Product Service Group CE Audio

Service Information

CORRECTIONS TO THE SERVICE MANUAL

SERVICE TEST PROGRAM - FLOW CHART

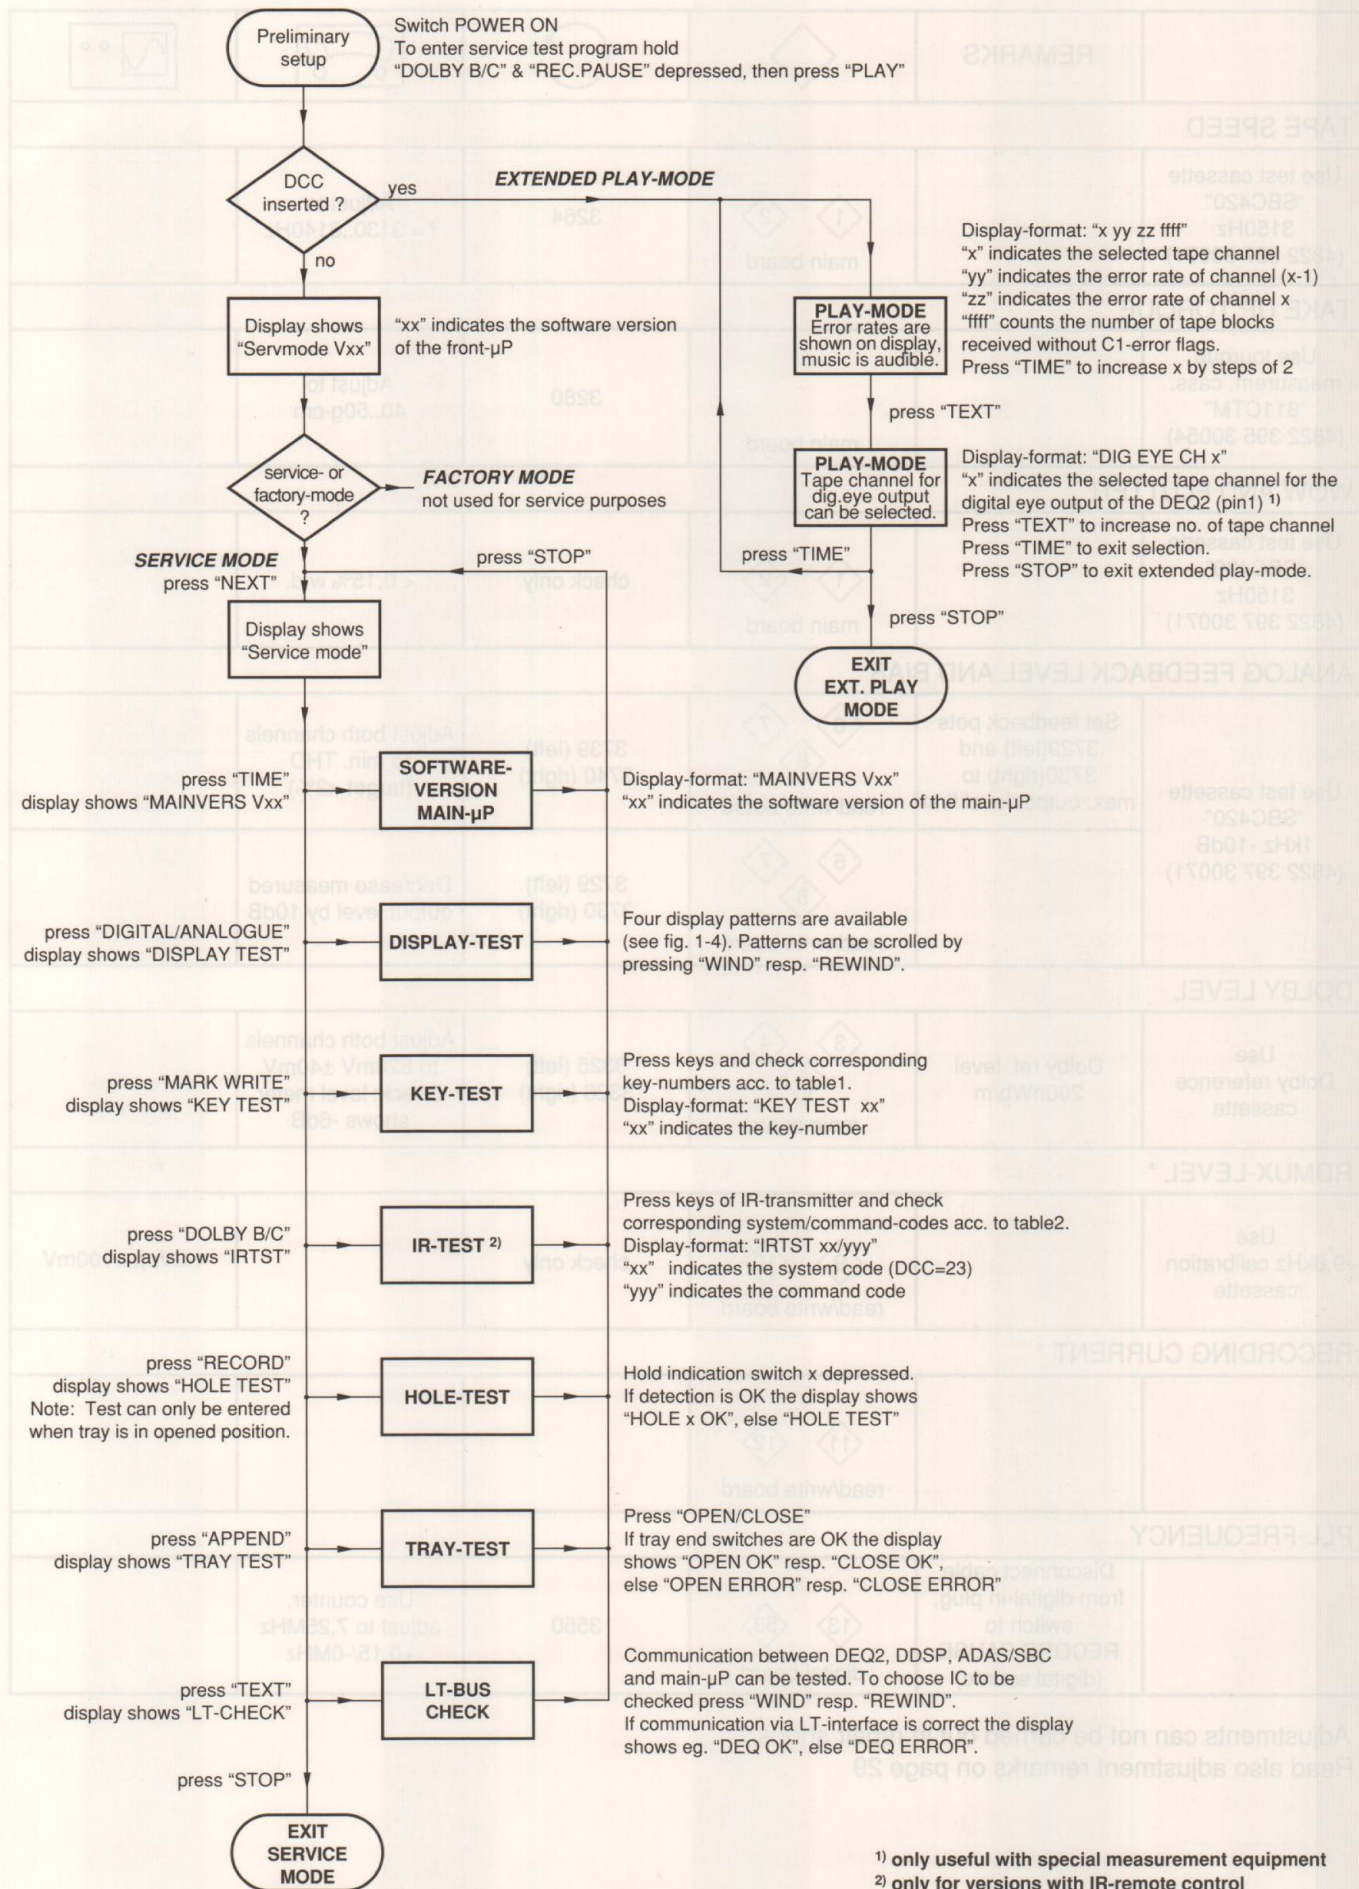
1. Service test program (page 25-26)

Flow chart drawing and test-descriptions on pages 25 and 26 have been updated to produced situation. Additional information to various test-modes has been added.

Key-test : Correct key to enter the test is "MARK WRITE".

Hole-test : The test can only be entered if tray is in opened position. To move tray outside execute tray-test, first.

IR-test : RC5-Codes of TEXT and TIME have been exchanged.

RC5-Code for TIME should read "11", RC5-Code for TEXT should read "12".

For corrected flow chart and descriptions see annex pages marked 25.a, 26.a and added page 26.1.

ADJUSTMENT TABLE

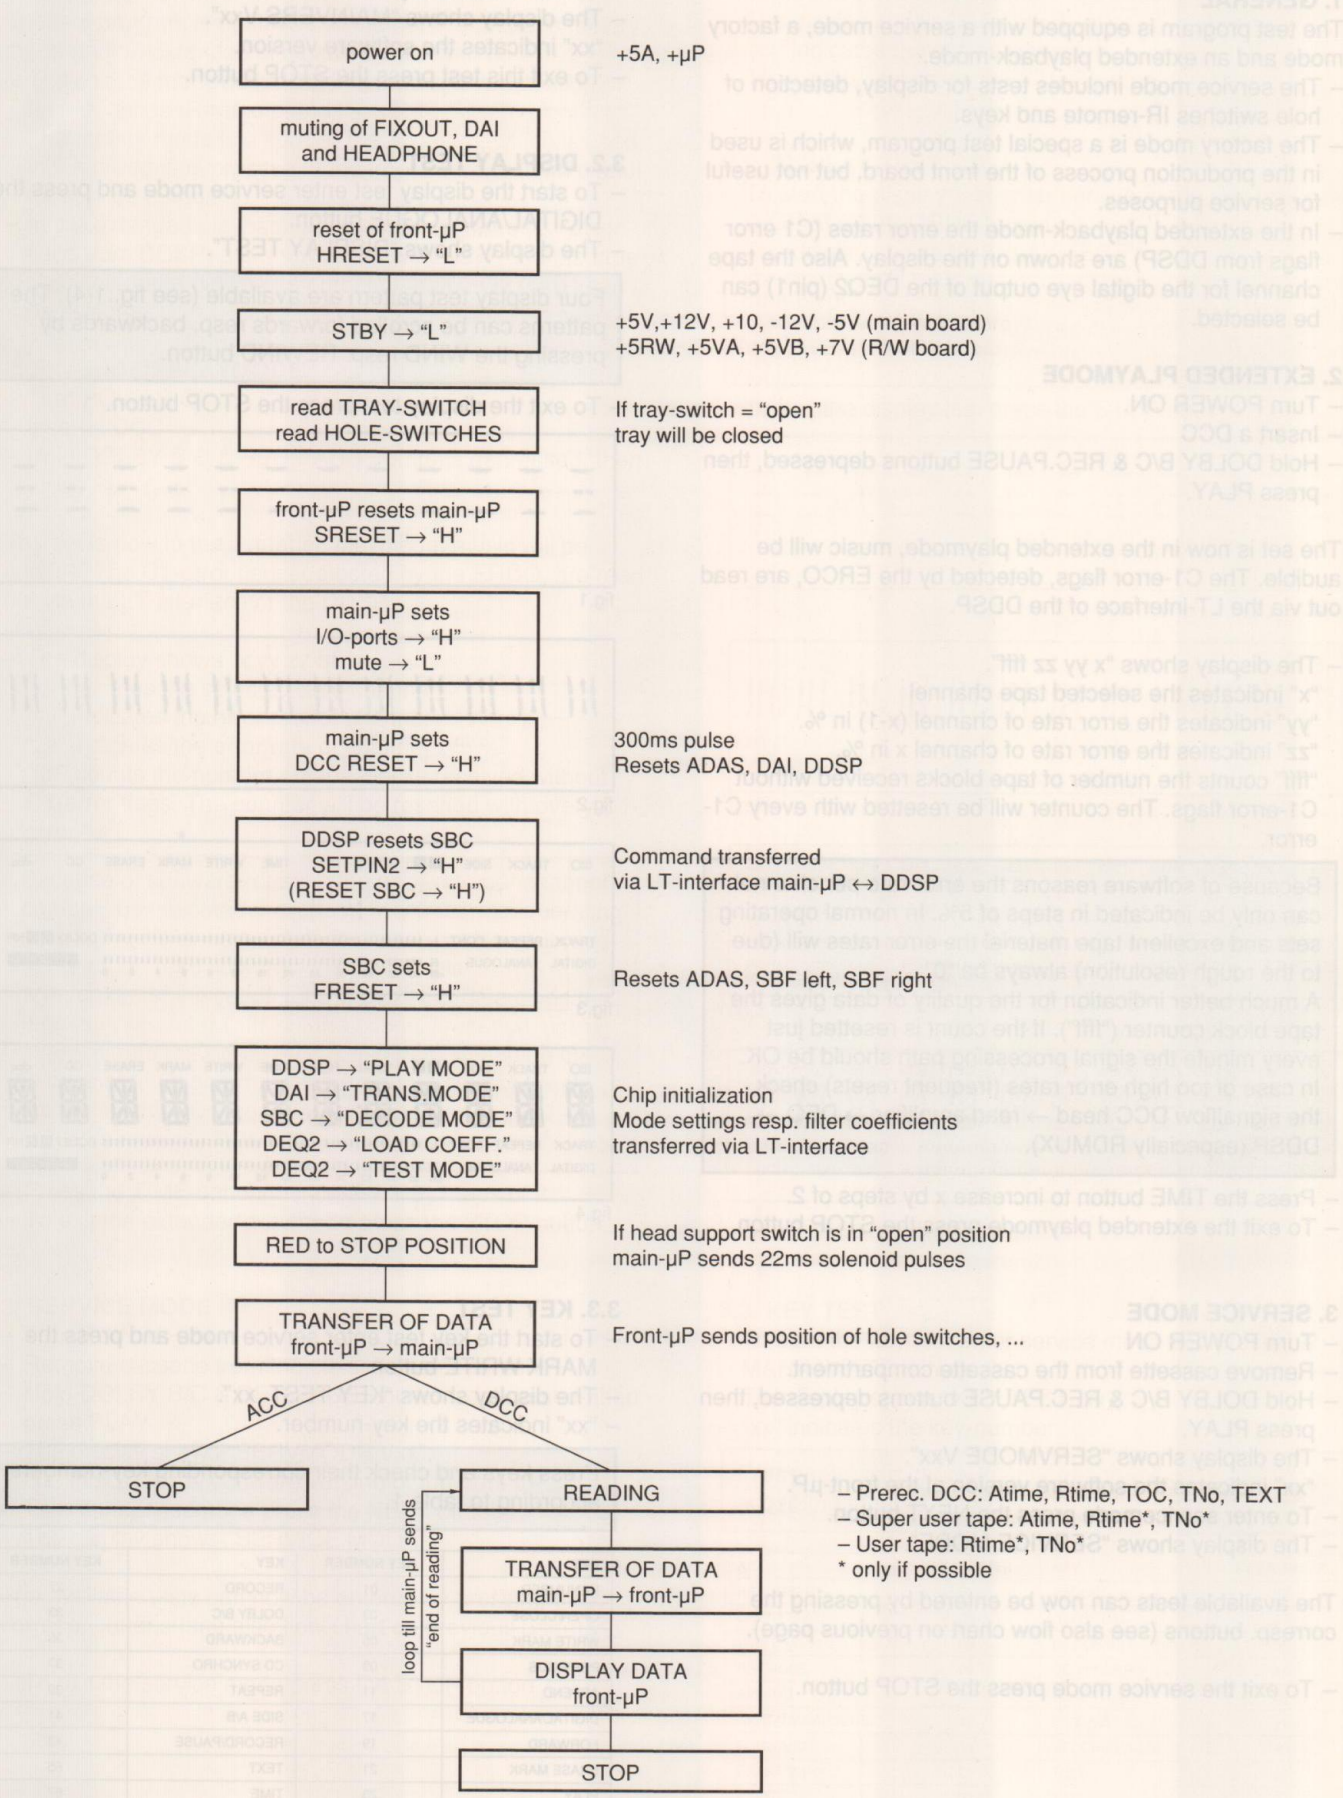
2. Adjustment table (page 28)

Position number of potmeter for take-up torque should read 3280 instead of 3220.

For corrected adjustment table see annex page marked 28.a which replaces the original page 28.

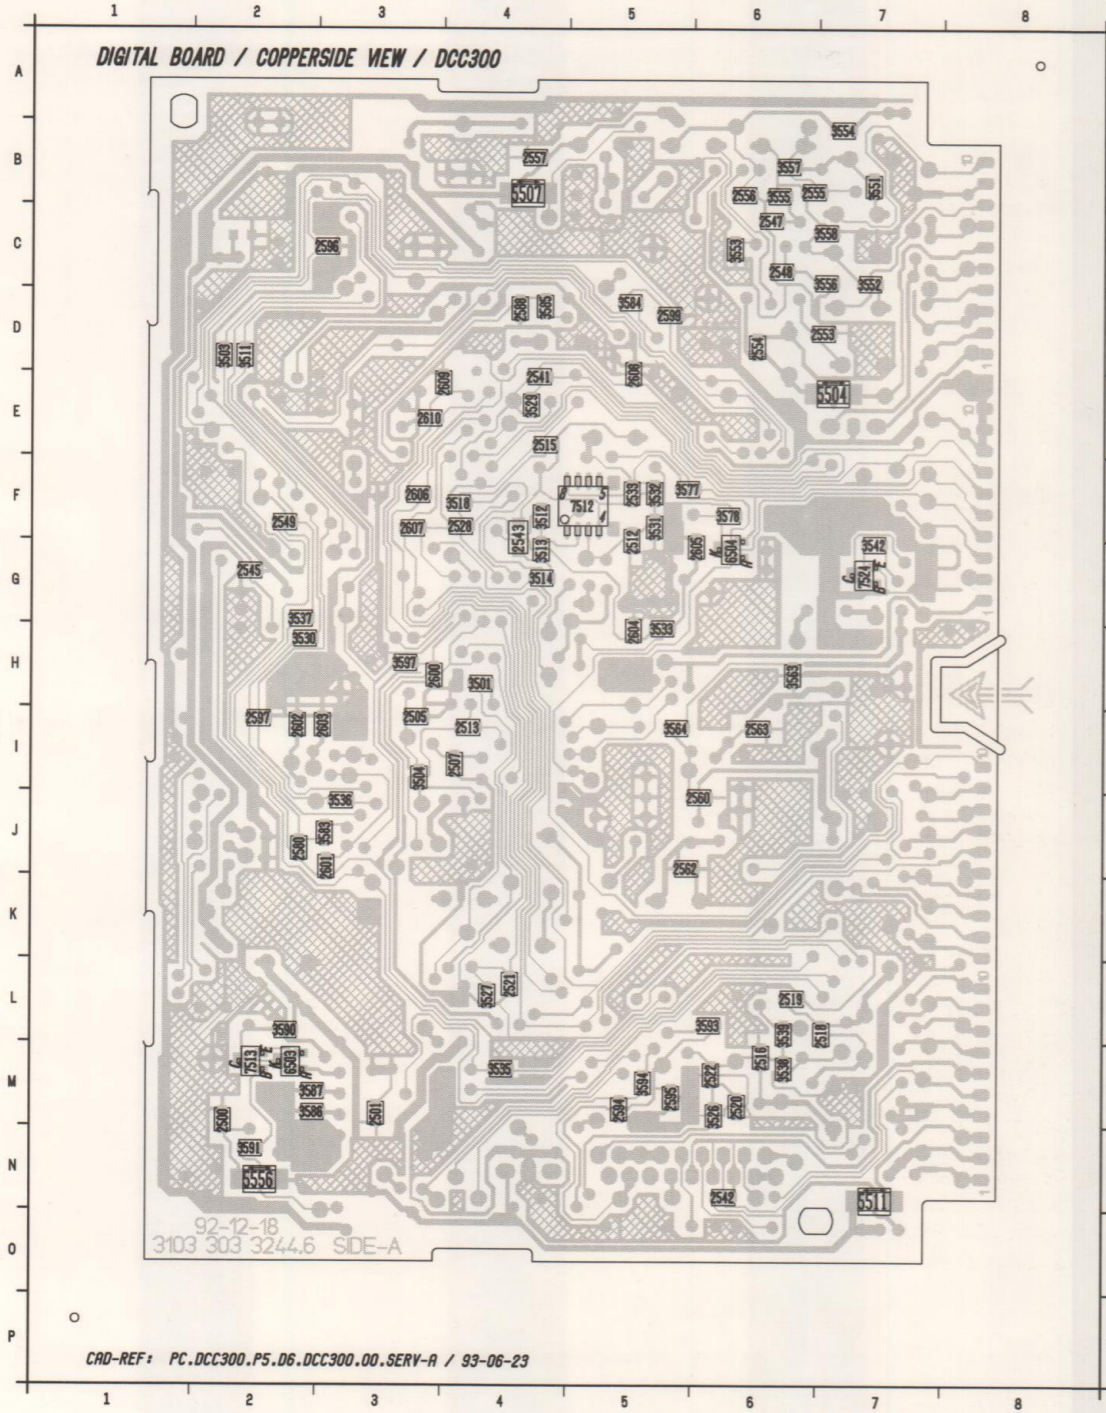
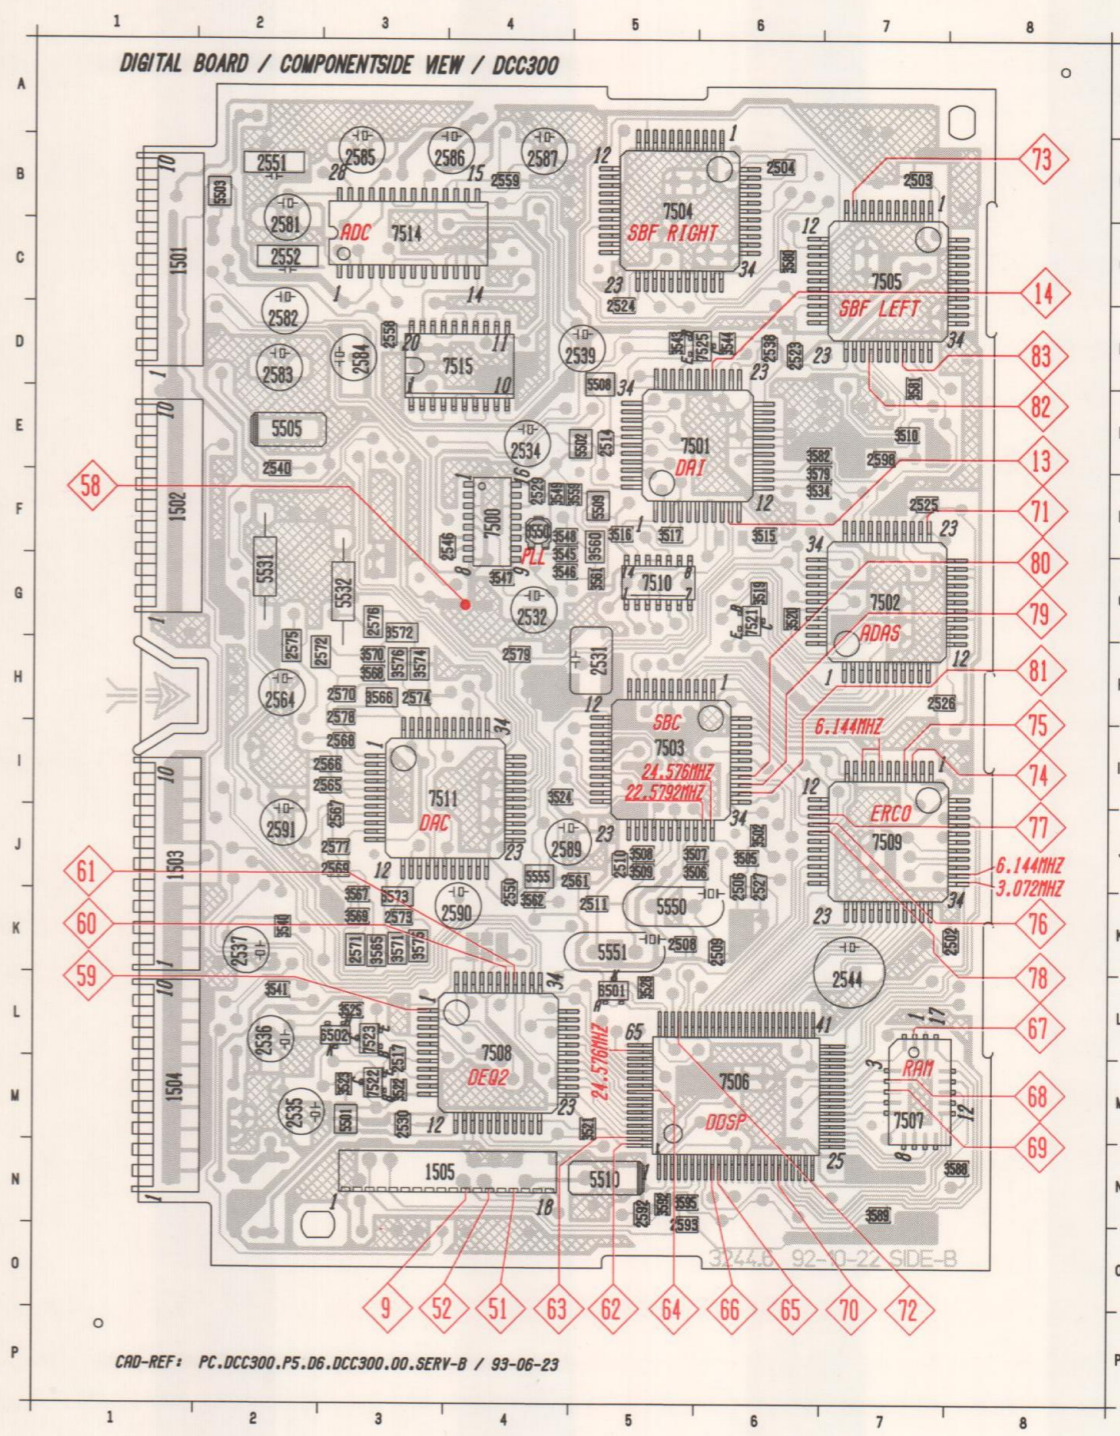
3. Measuring points on Digital Board PCB5 (page 44)

Position of red layer shifted in the printing process. Most measuring points can hardly be located.

For corrected layout see annex page marked 44.a which replaces the original page 44.
